Re: Docket No. 486: Tarpon Towers II, LLC Application for a Certificate of Environmental Compatibility and Public Need for the construction, maintenance, and operation of a telecommunications facility at 796 Woodin Street, Hamden, Connecticut

**INTERROGATORY RESPONSES TO CONNECTICUT SITING COUNCIL
FROM APPLICANT TARPON TOWERS II, LLC**

Site Location Map

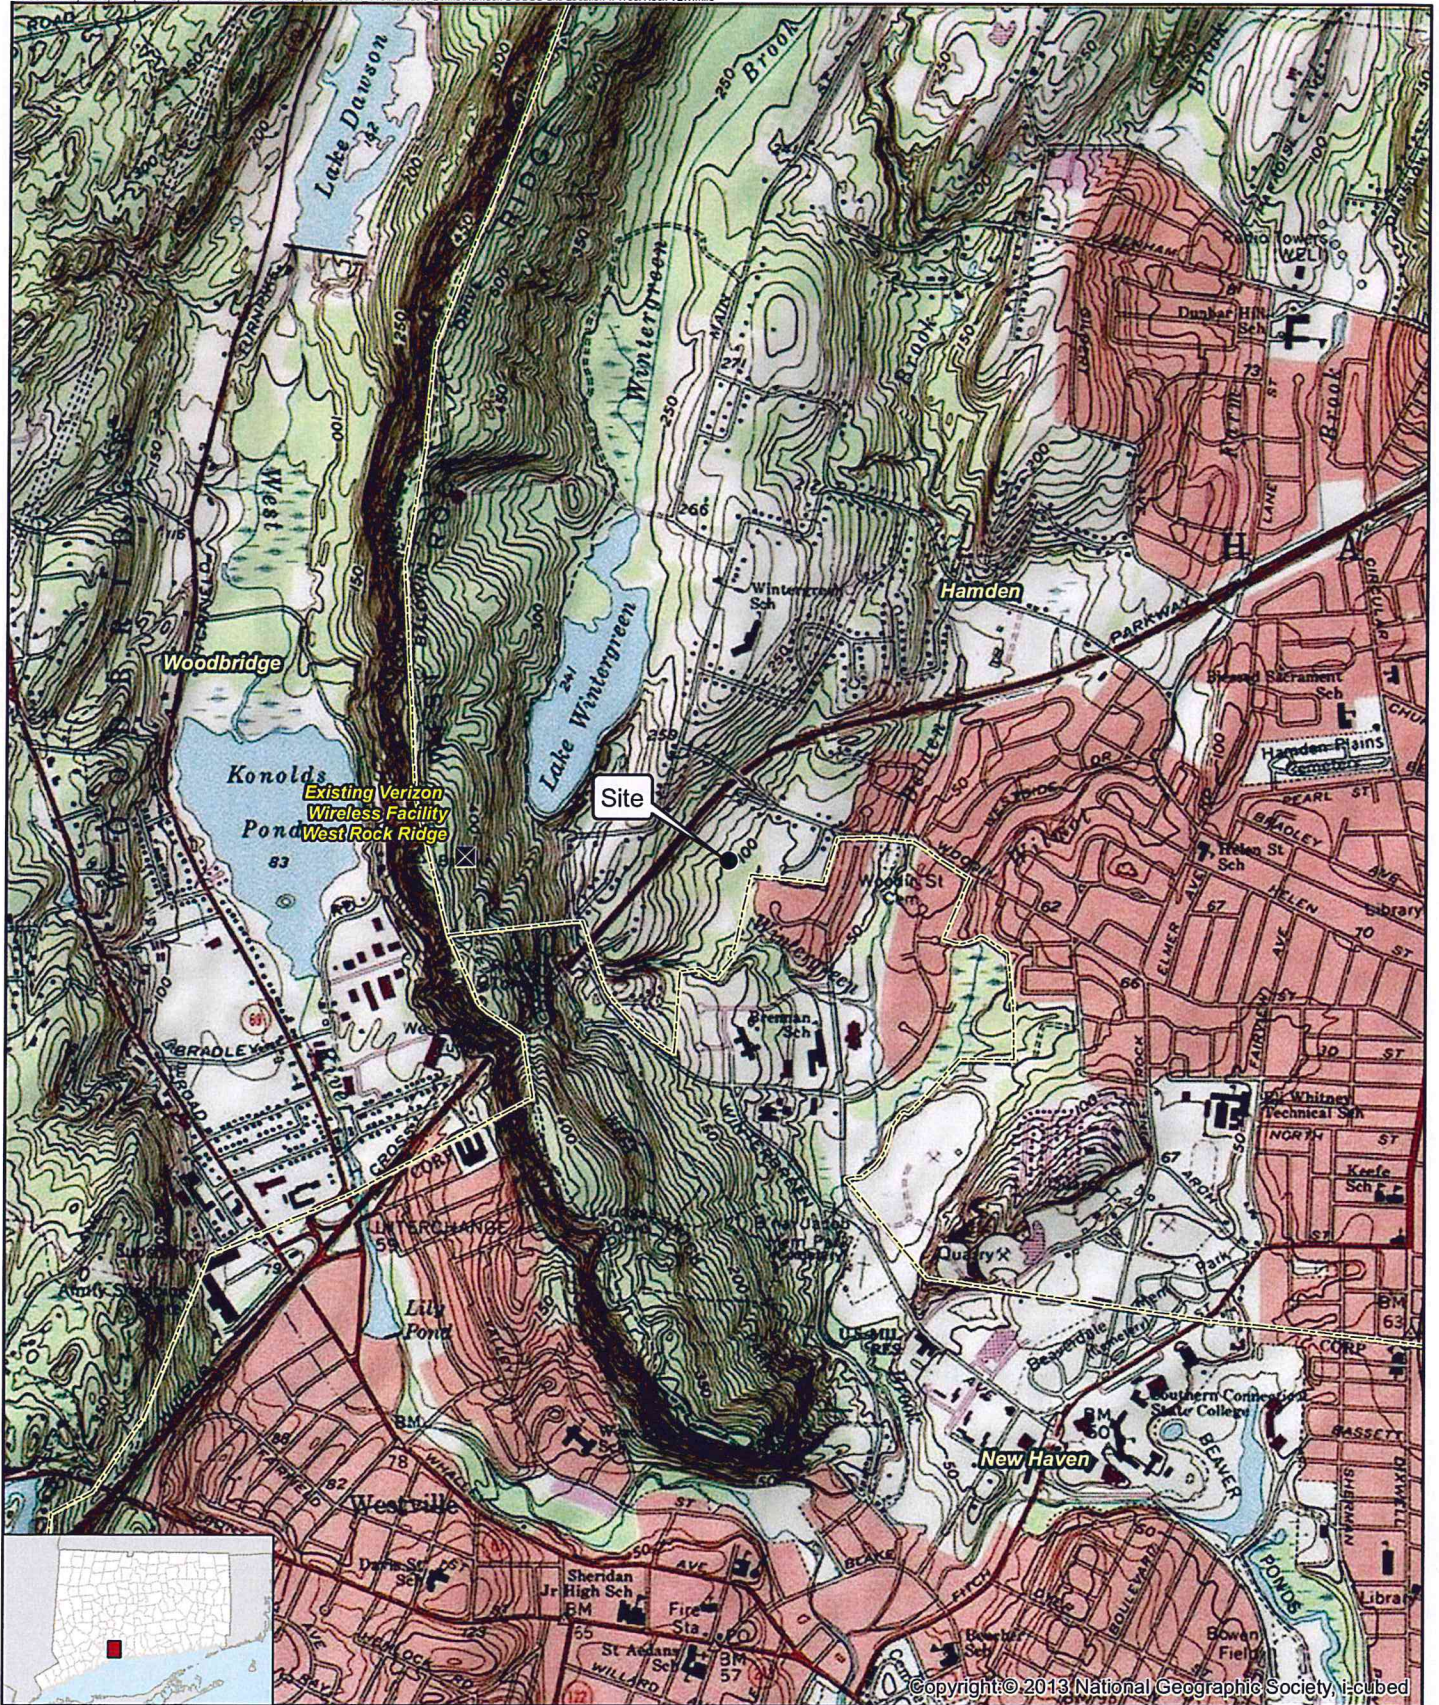
10. Application p. 2 states Verizon intends to relocate from an existing tower on West Rock Ridge to the proposed site. Using the Site Location Map provided in the Application Executive Summary, indicate the location of both the Proposed Site and Verizon's existing West Rock Ridge site.

RESPONSE: See Map attached hereto as Attachment 1.

Farmland Soils
Proposed Wireless Telecommunications Facility
 Hamden CT Rele
 796 Woodin Street
 Hamden, Connecticut

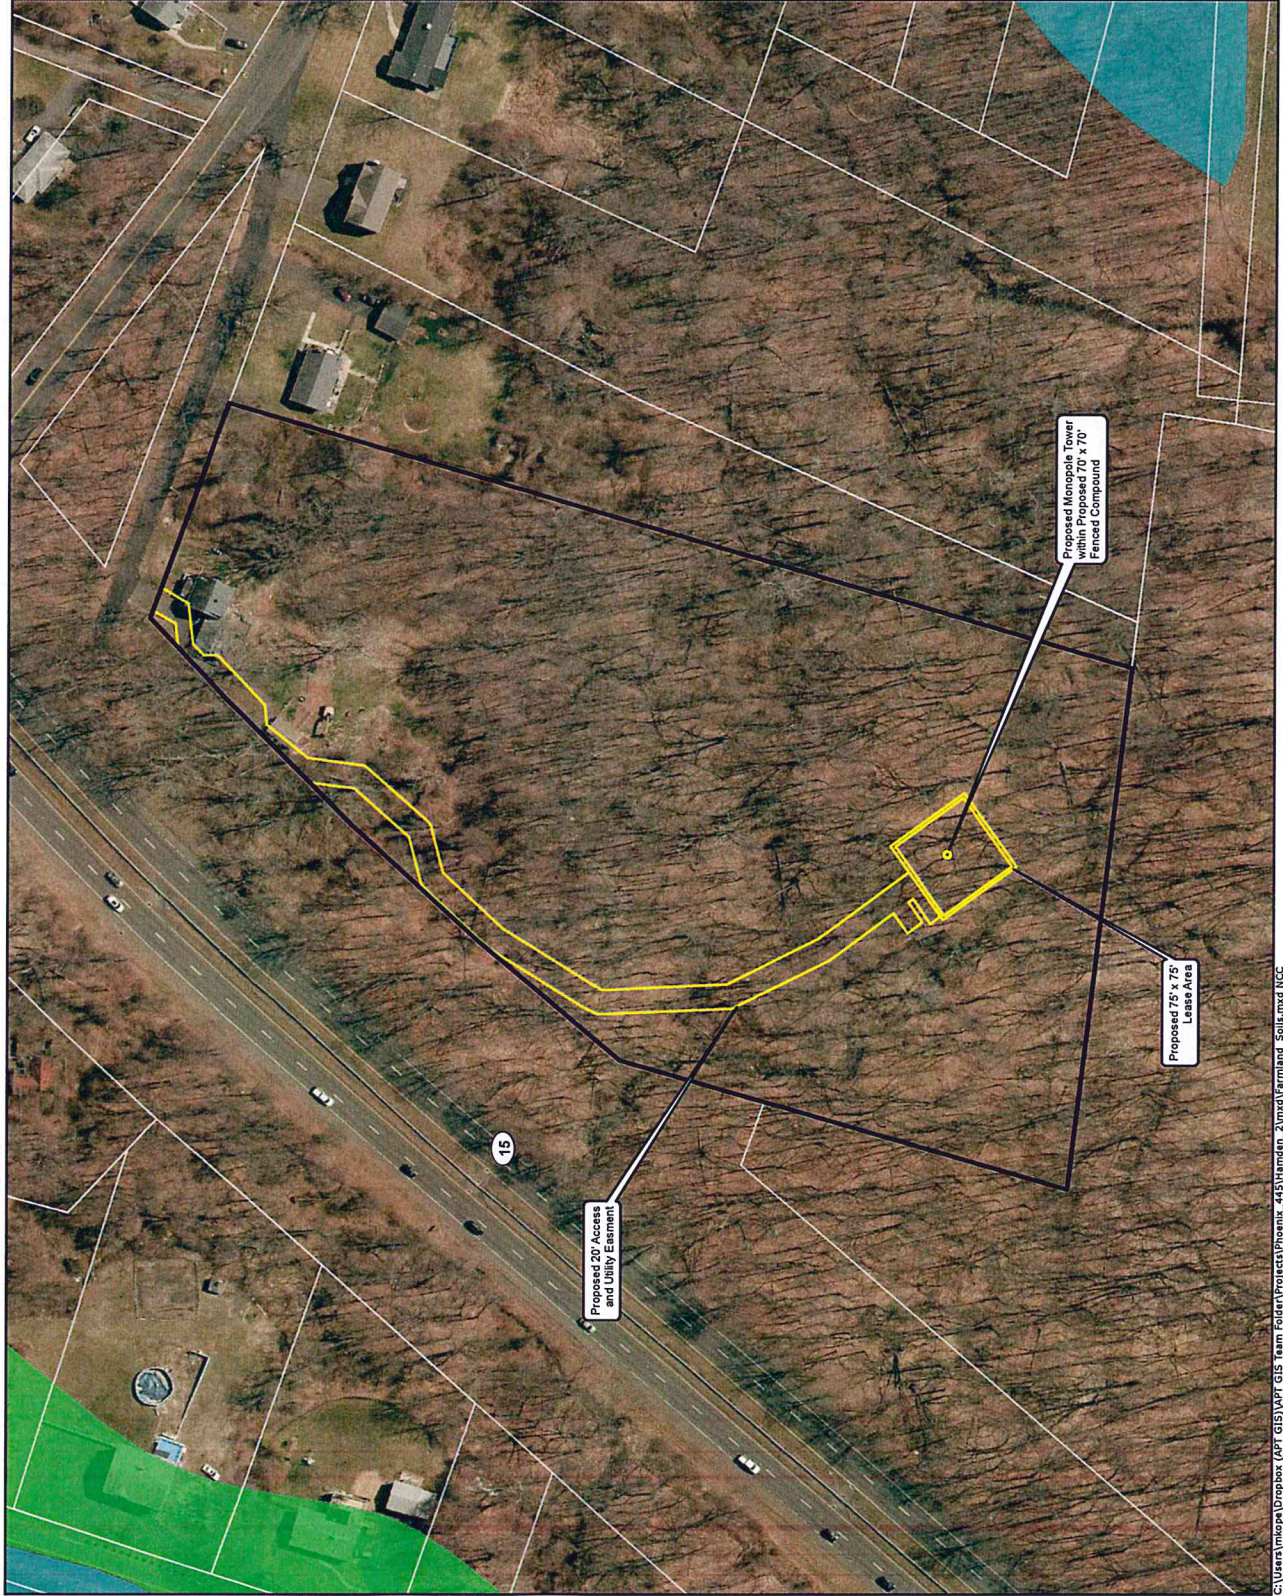
20. Is any portion of the proposed facility on prime farmland soils, as mapped by the CT Natural Resource Conservation Service? If so, estimate the amount of mapped prime farmland soils that would be impacted by the proposed facility.

No Prime Farmland Soils or Statewide Important Farmland Soils are located within the proposed facility or on the subject property. As a result, the proposed facility will not adversely affect farmland soils.

Please refer to the Farmland Soils Map attached hereto as Attachment 3.

SHEET NUMBER
C-2

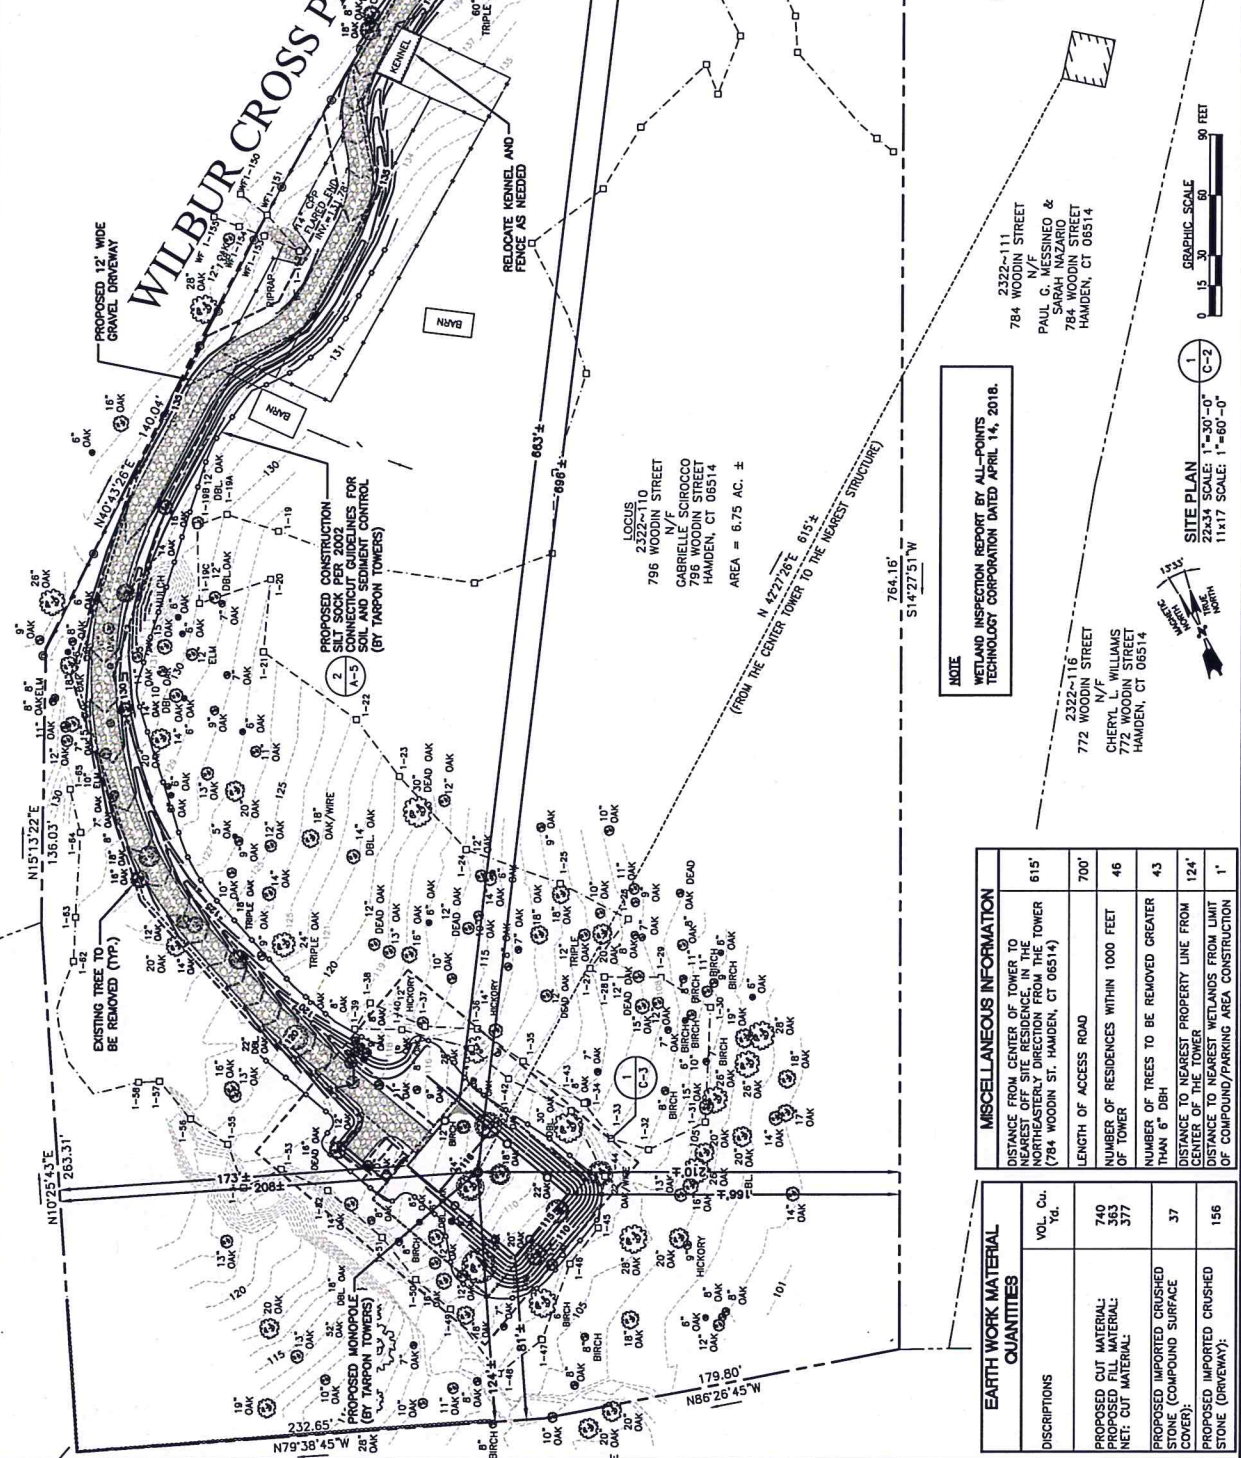
13. Referring to Applicant Exhibit E, Sheet C-2- Miscellaneous Table, provide the following:
- a) direction and address of the nearest residential structure; and
 - b) point of reference for each value e.g., compound or tower.

- a) The nearest residential structure 784 Woodin Street is 615 feet northeast from tower center.
- b) The nearest residential structure 784 Woodin Street is 595 feet northeast from site compound.

SHEET NUMBER
A-1

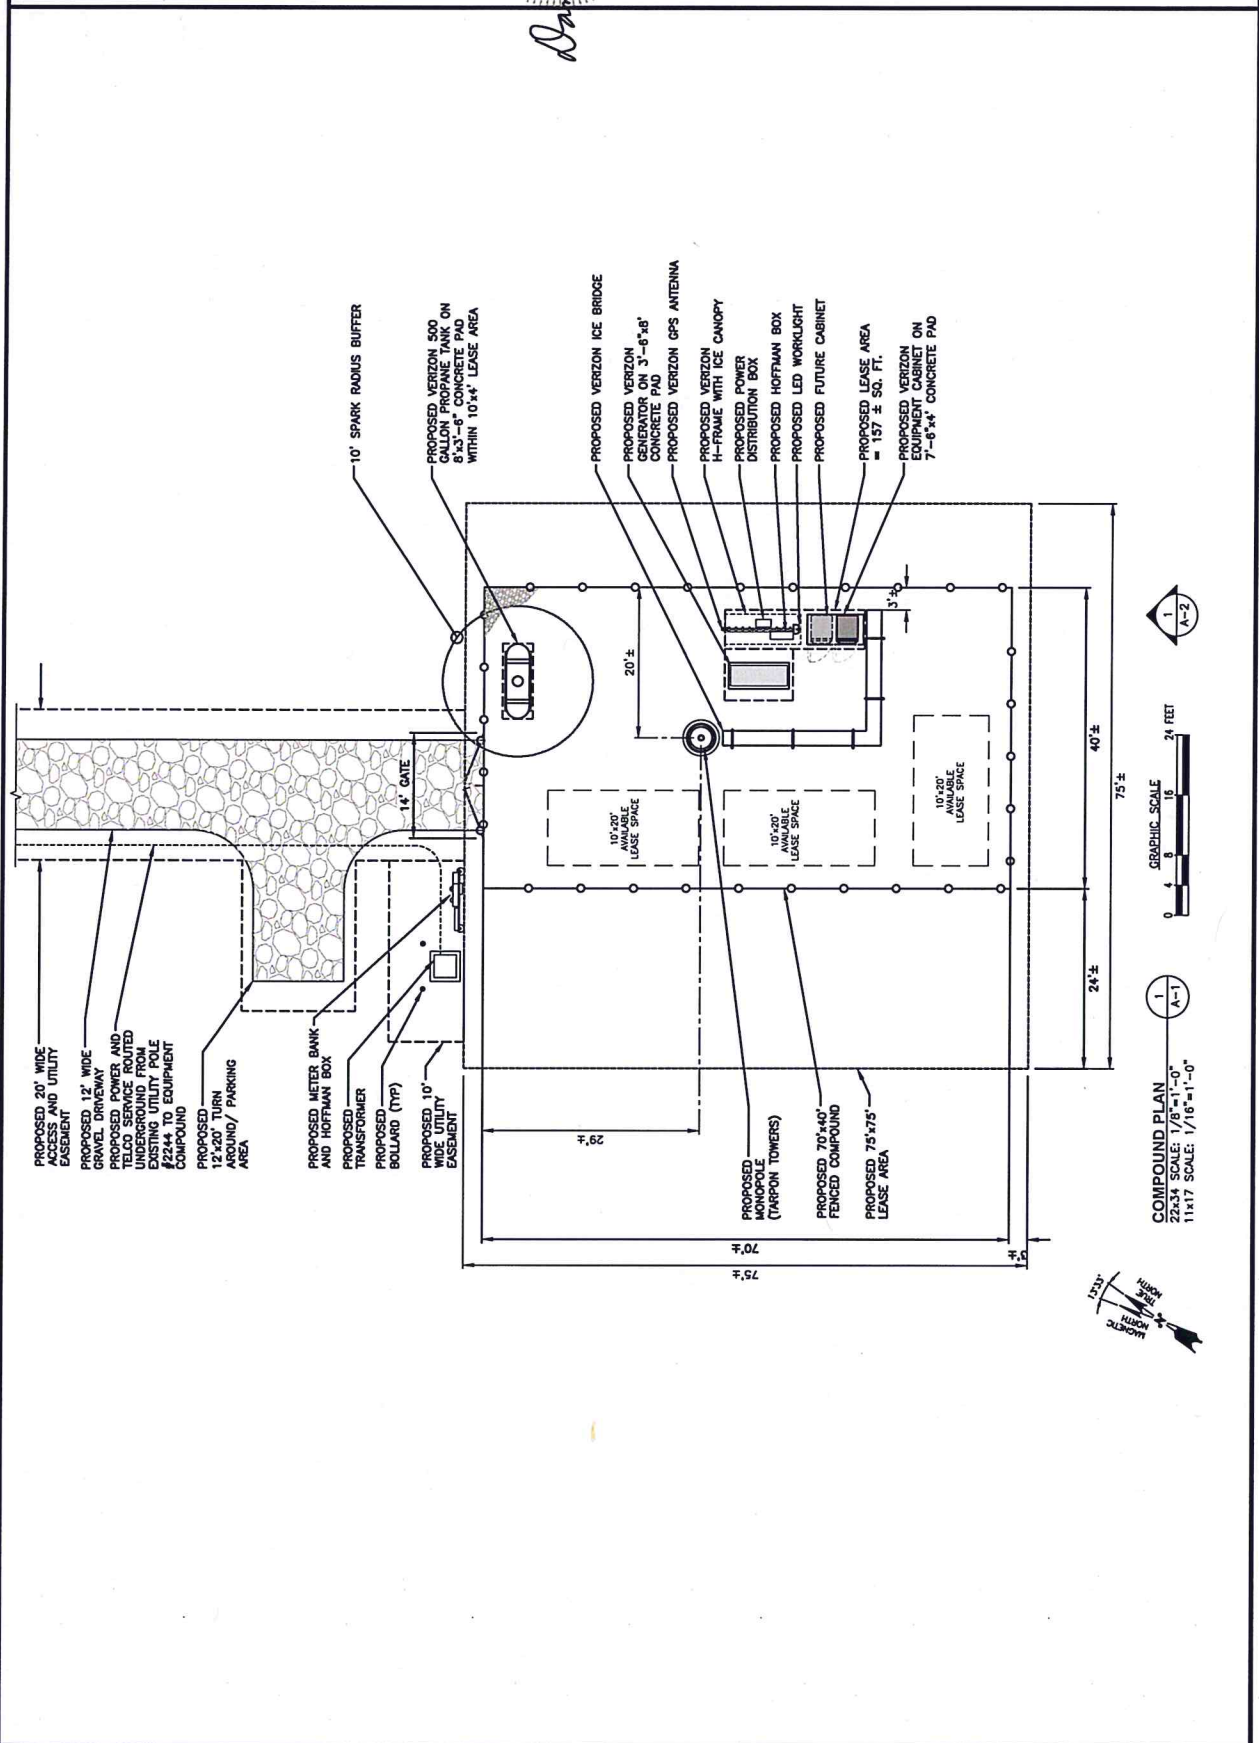
22. Application Exhibit M contains a Wetland Inspection Map that depicts a 70-foot by 40-foot compound. Revise the map to account for the 70-foot by 70 foot compound, as identified in Interrogatory Response #8.

26. If Interrogatory Response #8 states the compound is 70 feet by 70 feet, why did the public notice in Interrogatory Responses Set 1, Attachment 1 list a 70-foot by 40-foot compound?

A revised set of plans have been entered to show the 70 foot by 40-foot compound in an effort to mitigate any impact to the wetlands is attached hereto as Attachment 4.

The dimensions of the associated equipment compound was originally planned to be approximately 70 feet x 70 feet, however after the inland wetlands analysis was conducted and the results were discussed with Tarpon and All Points, the proposed dimension of the compound was reduced from 70 feet by 70 feet to 70 feet by 40 feet. Reducing the size of the compound increased the distance of the proposed project from the wetlands.

SOUTH ELEVATION
 SCALE: 1/8"=1'-0"
 11x17 SCALE: 1/16"=1'-0"

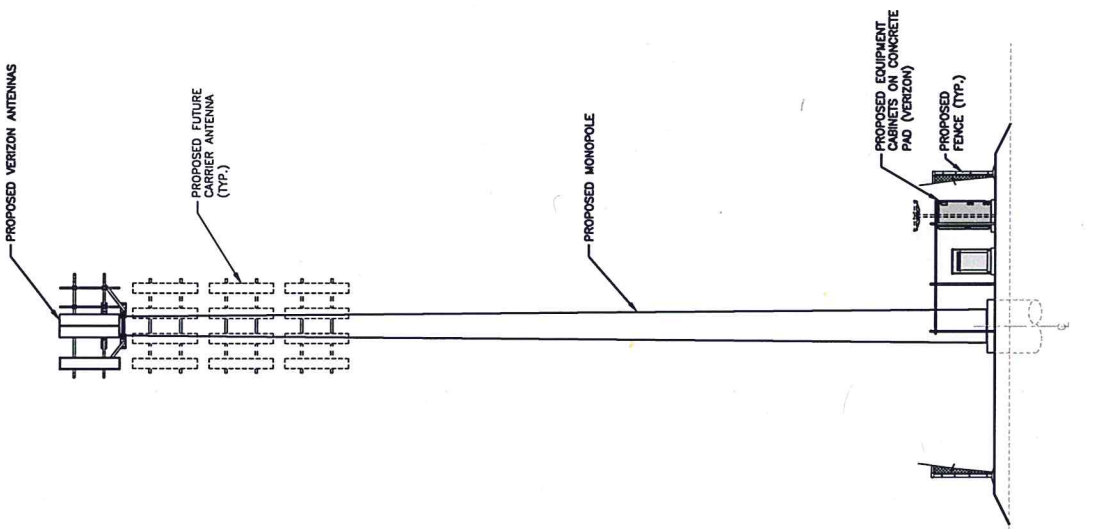
25. Referring to Interrogatory Response #9, what does the 240 feet above mean sea level figure represent?

The elevation of the ground at the proposed site is currently 113' above mean sea level. The finished grade after construction will be 116' feet above mean sea level. The top of the tower with appurtenances is 124 feet above ground level. The total height of the tower post construction will be 240 feet above mean sea level.
